TO: Mercedes-Benz Dealer Principals, General Managers, Sales Managers, Service Managers, Parts Managers	FROM: Gregory Gunther, Senior Manager, Vehicle Compliance and Analysis, Engineering Services
RE: <b>Recall Campaign Launch Notification</b> <b>Correct Bolting of Rear Axle Differential</b> <b>MY24 GLC and S-Class (254 and 223)</b>	DATE: January 3, 2025

Campaign No. 2024120005, January 2025

SUBJECT: **Model GLC and S-Class (254 and 223 platform)**  
**Model Year 2024**

## **Correct Bolting of Rear Axle Differential**

Figure 1

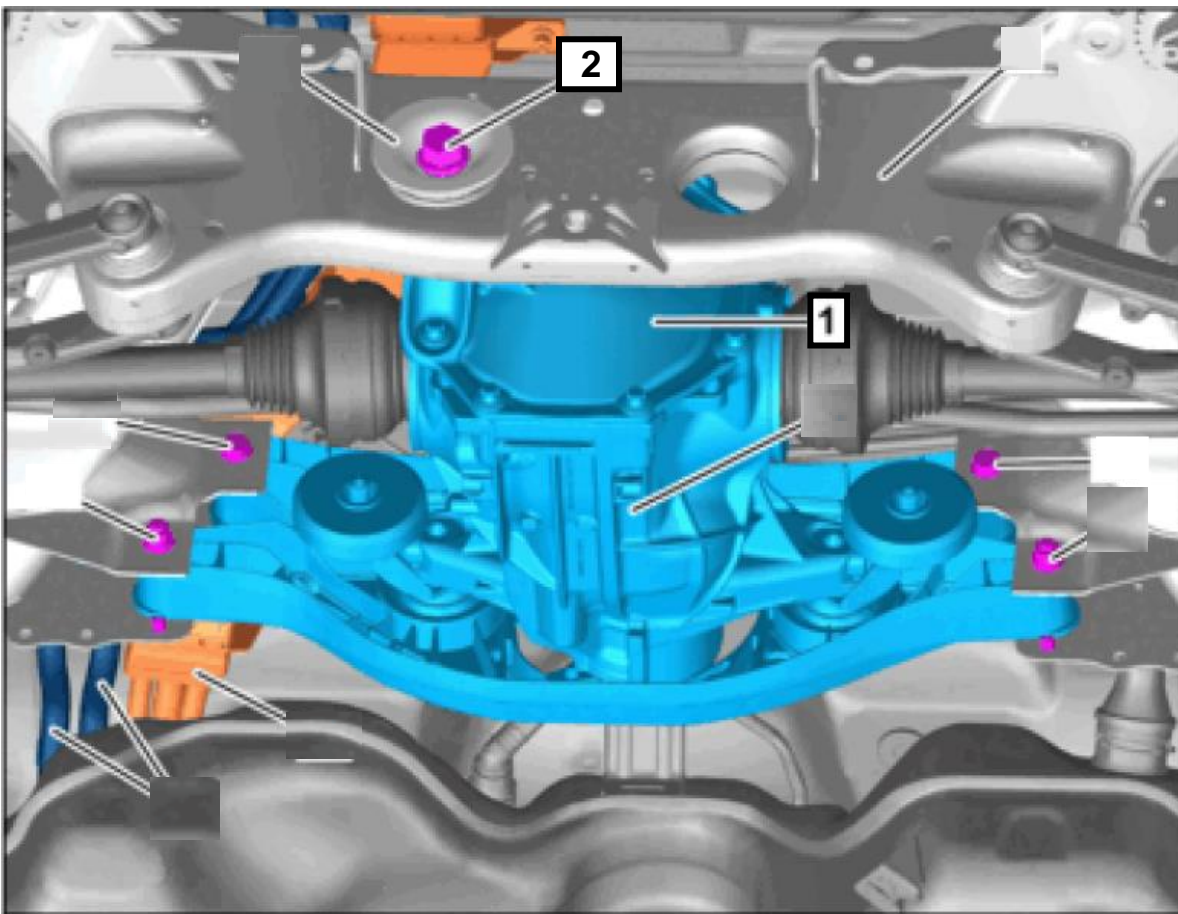
1. Replace rear axle differential end cover (**Figure 1, 1**).

**i** The rear axle differential **screw** to the rear cross brace (**Figure 1, 2**) must always be **replaced**.

**Nm** Observe the specified tightening torque, see:  
BA35.10-P-1005-01U (model 254)  
BA35.10-P-1011-01R (model 223).
